Bristol Airport Expansion to 12 million passengers per annum Planning Appeal

Rebuttal Proof of Scott Witchalls

On behalf of **Bristol Airport Limited**

Project Ref: 332110139/5502 | Rev: - | Date: July 2021

Appendix H A38/ West Lane Minor Alterations

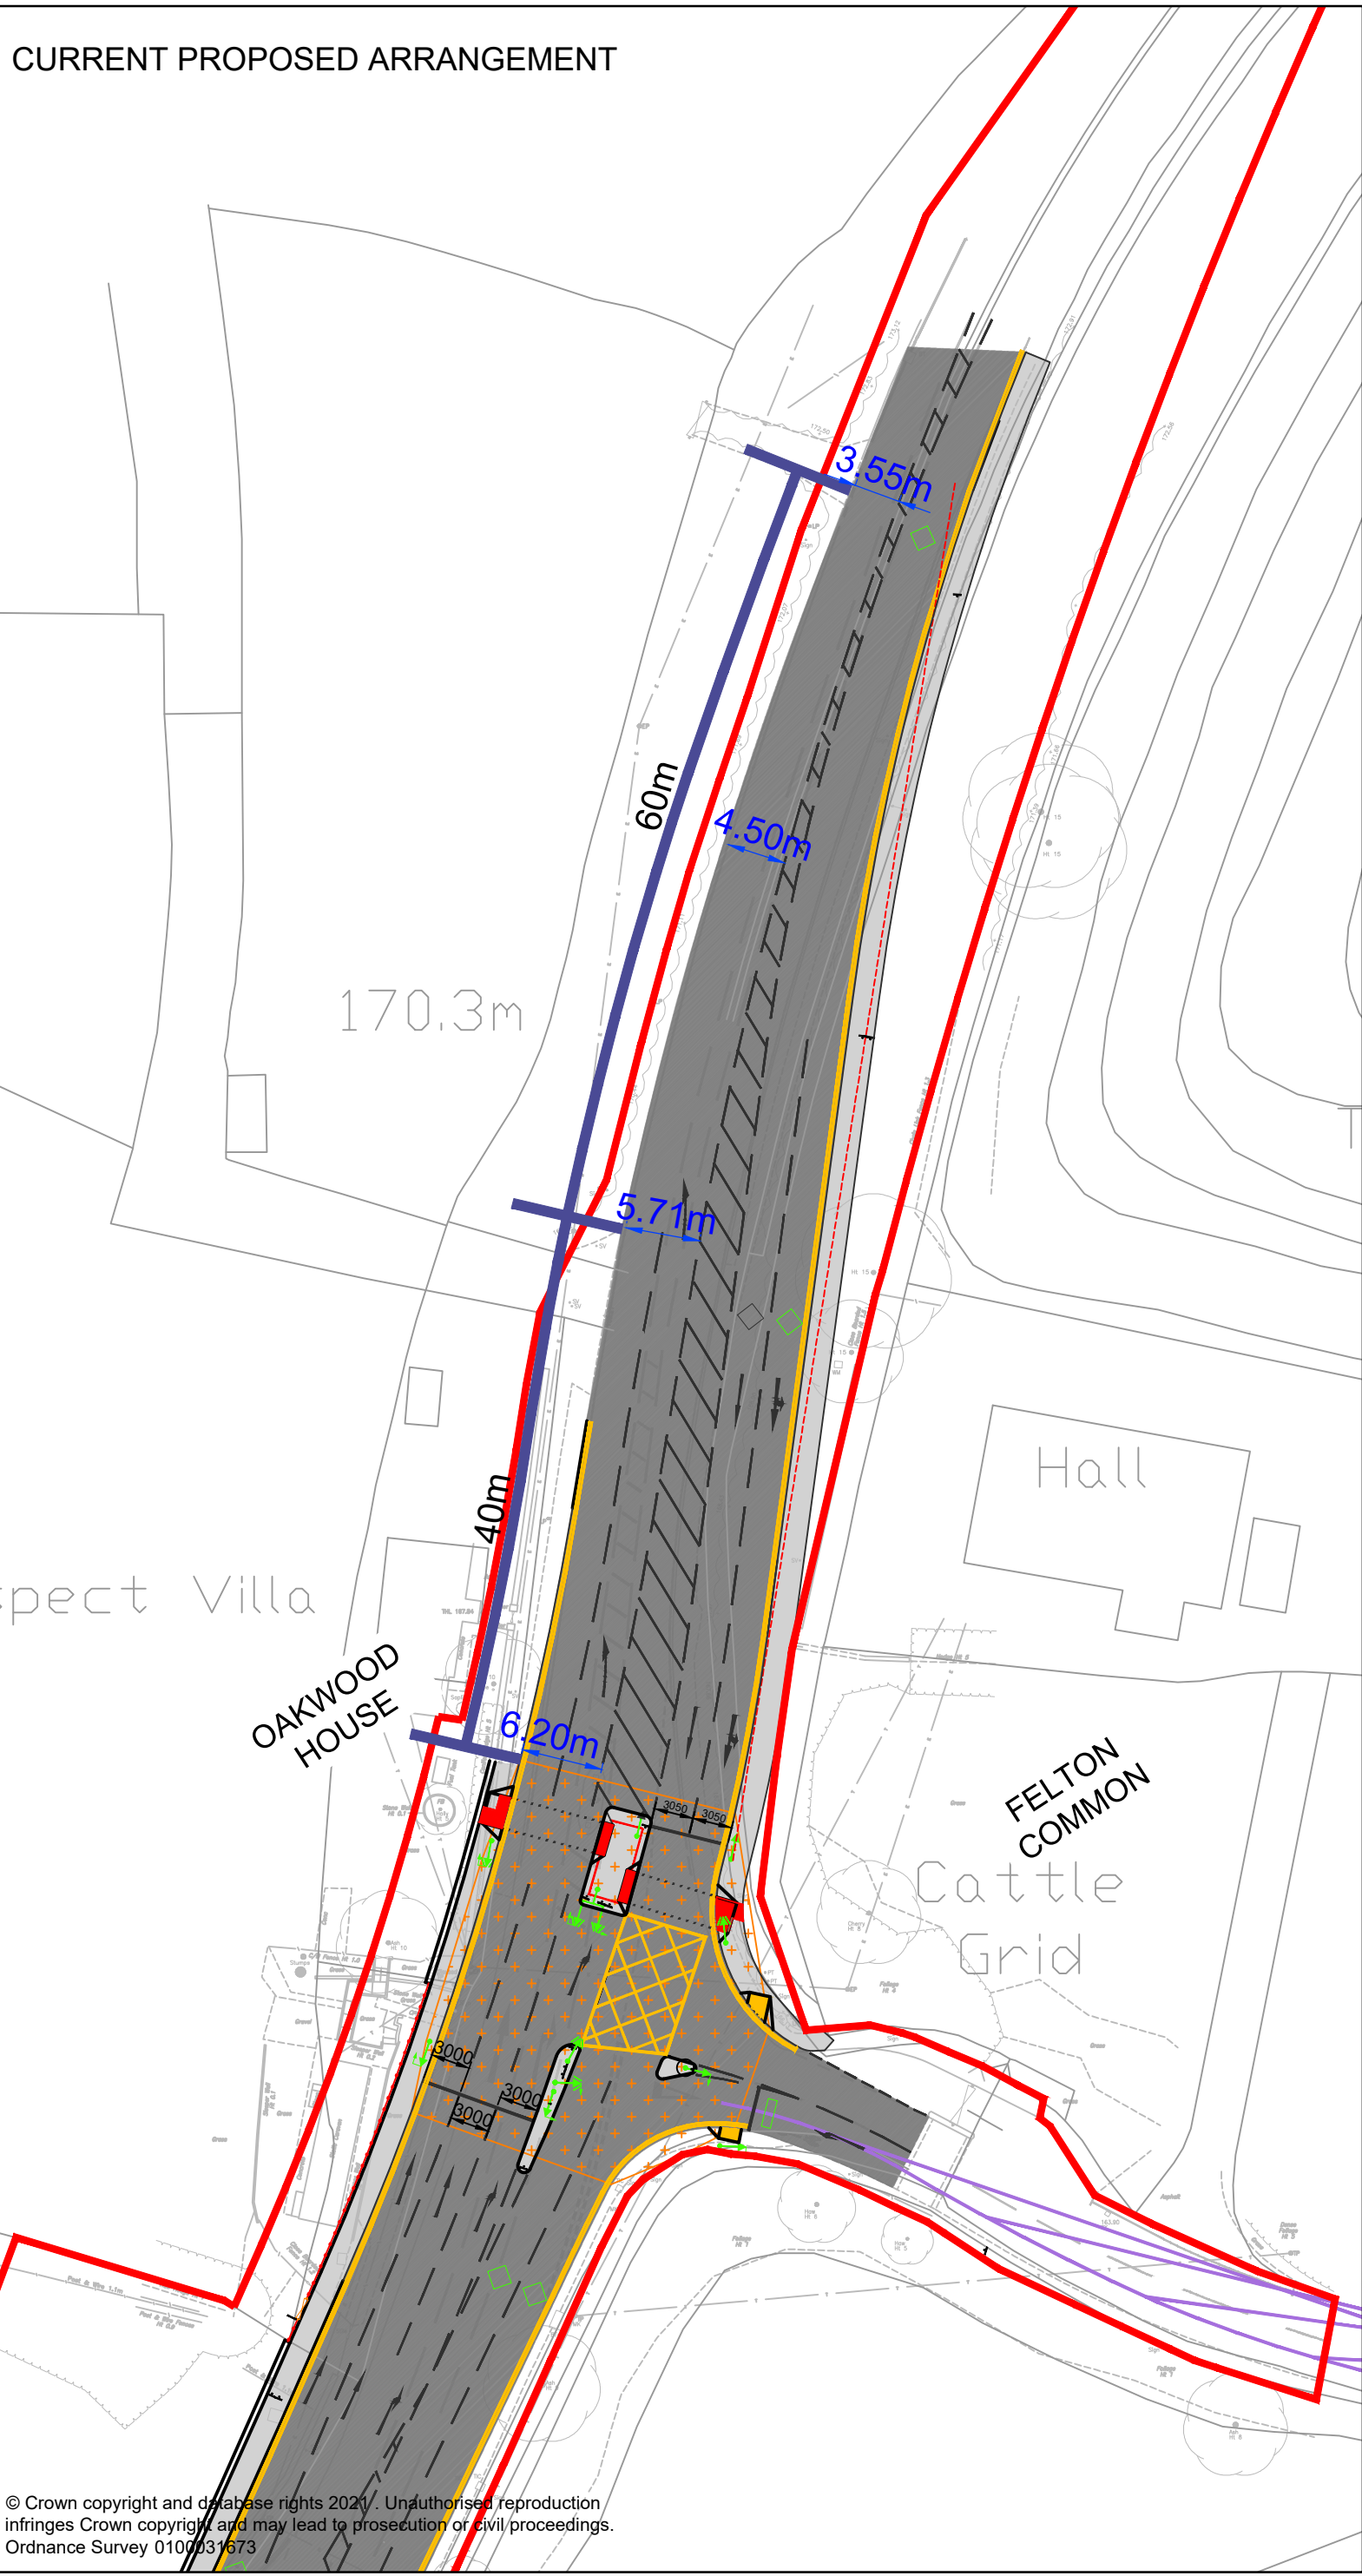
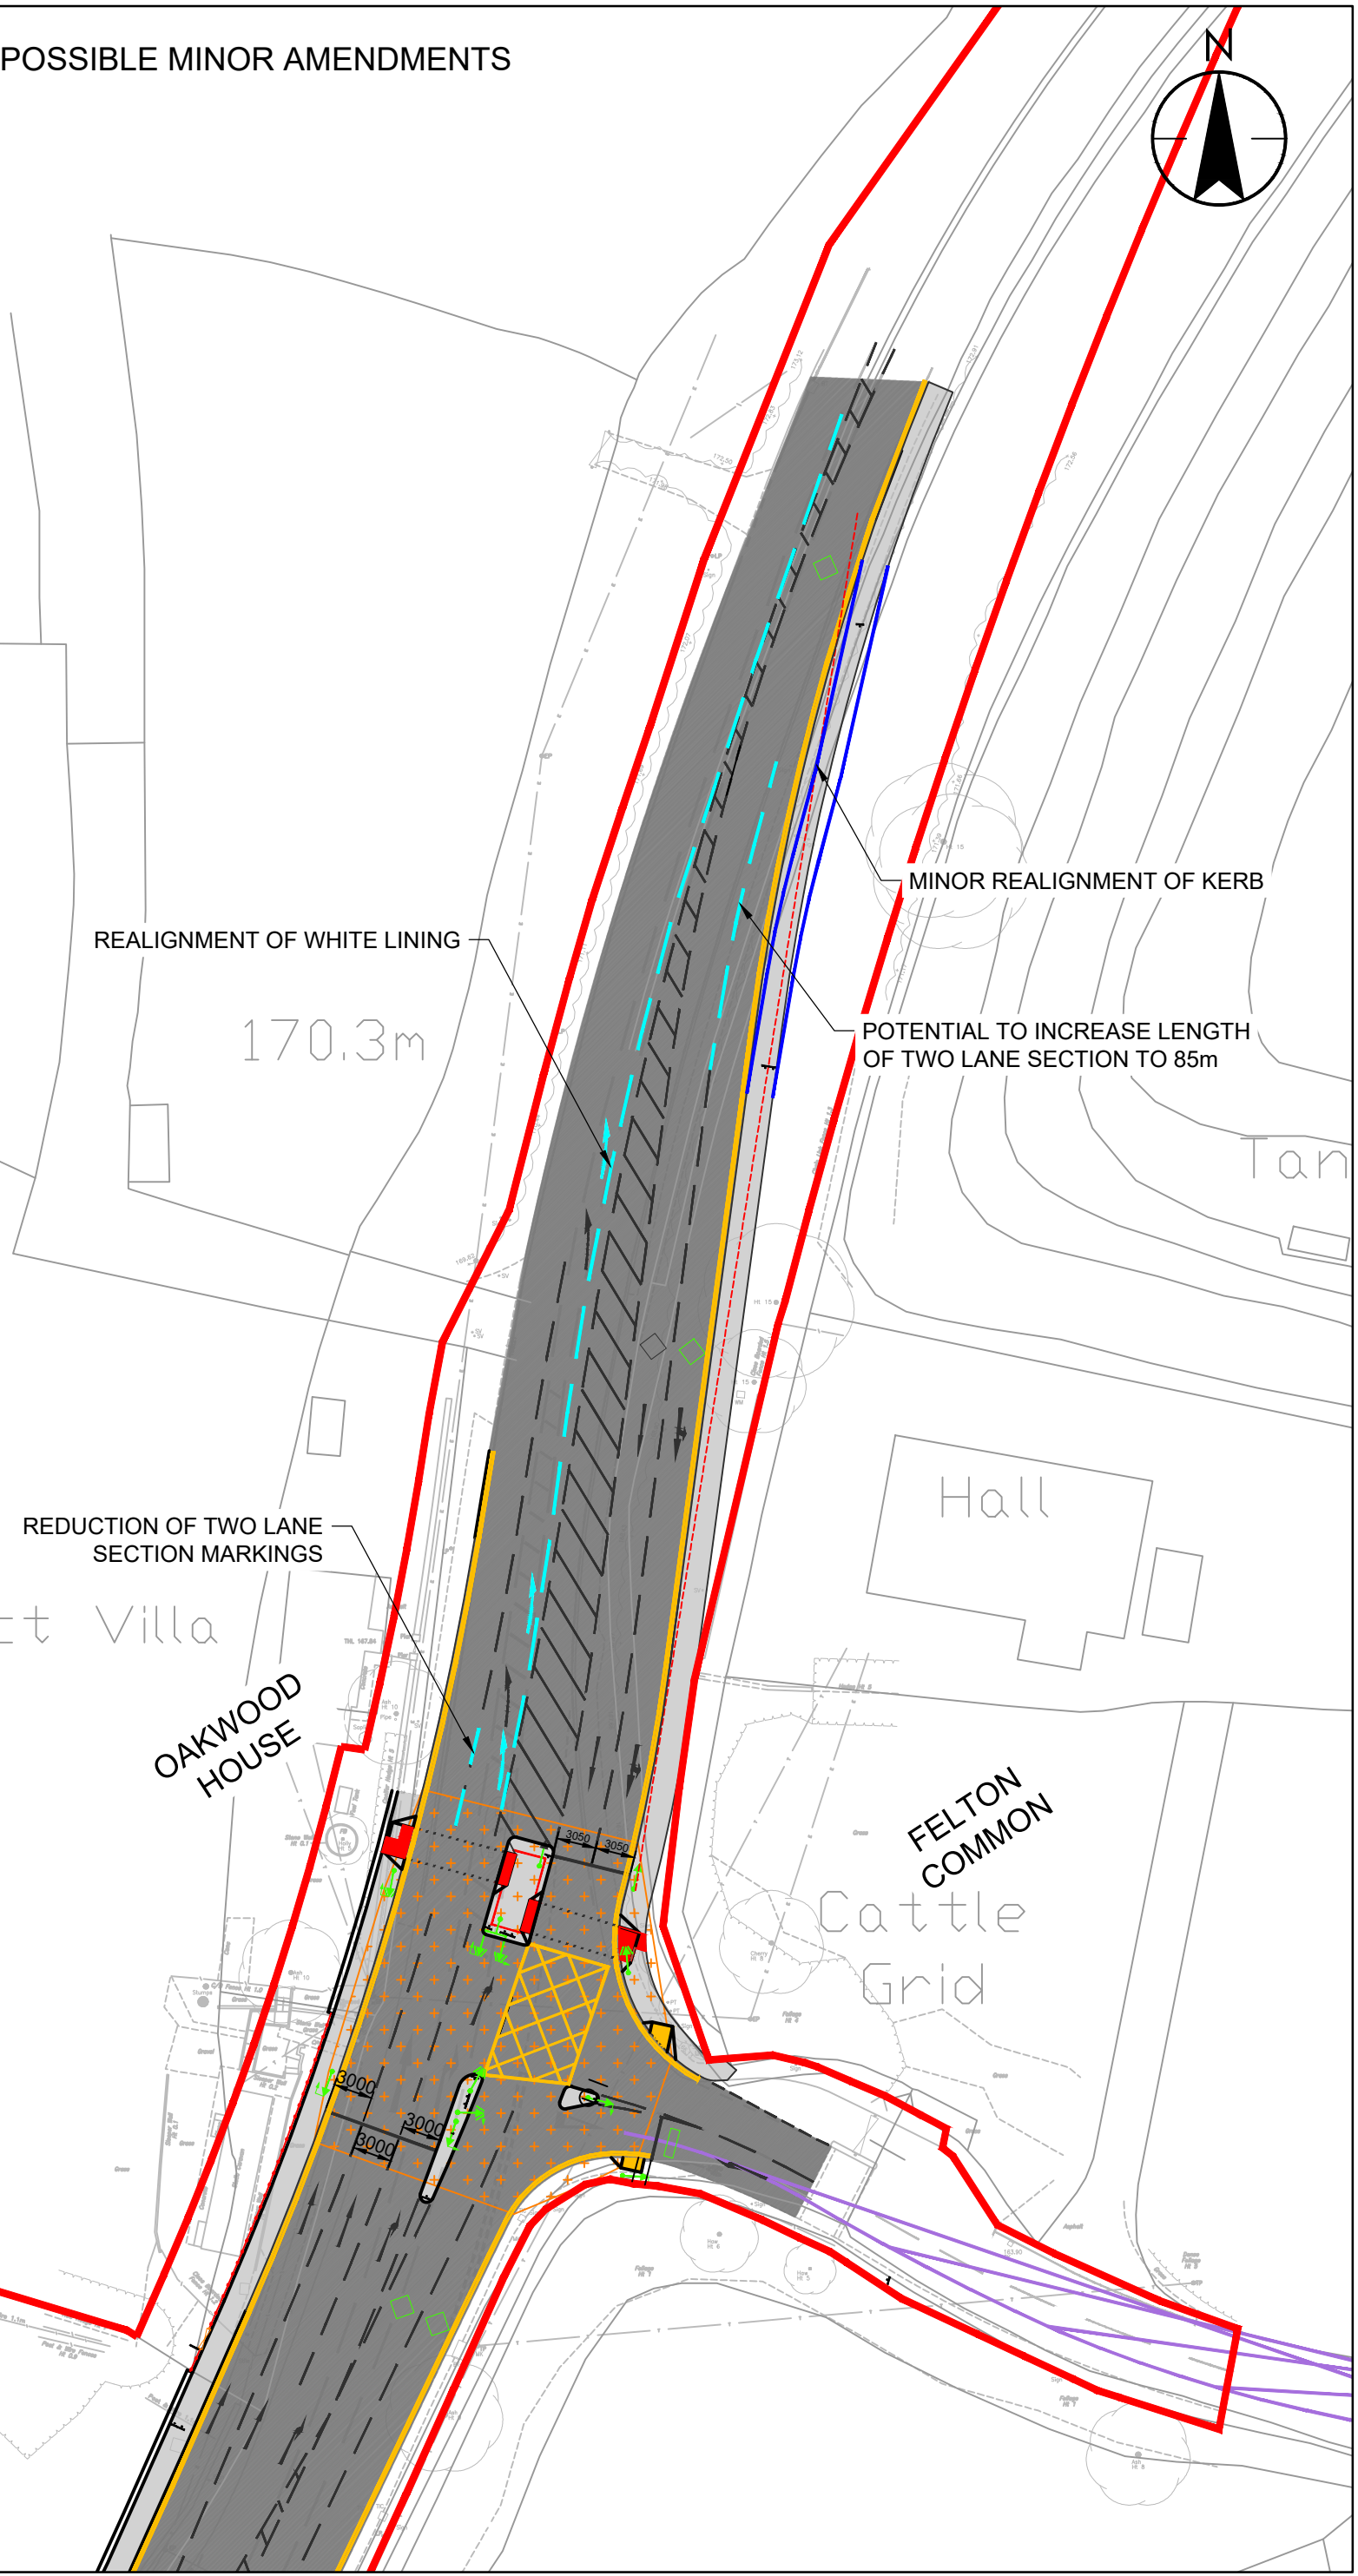
- 2.2.81 Notwithstanding the above, I have updated the worst-case PM peak assessments to allow for the crossing being called up between 5 and 6 times per hour (based on the **Appendix H** minor modification). The results of this assessment demonstrate that the junction would still operate within capacity (**Appendix F**).

CURRENT PROPOSED ARRANGEMENT

POSSIBLE MINOR AMENDMENTS
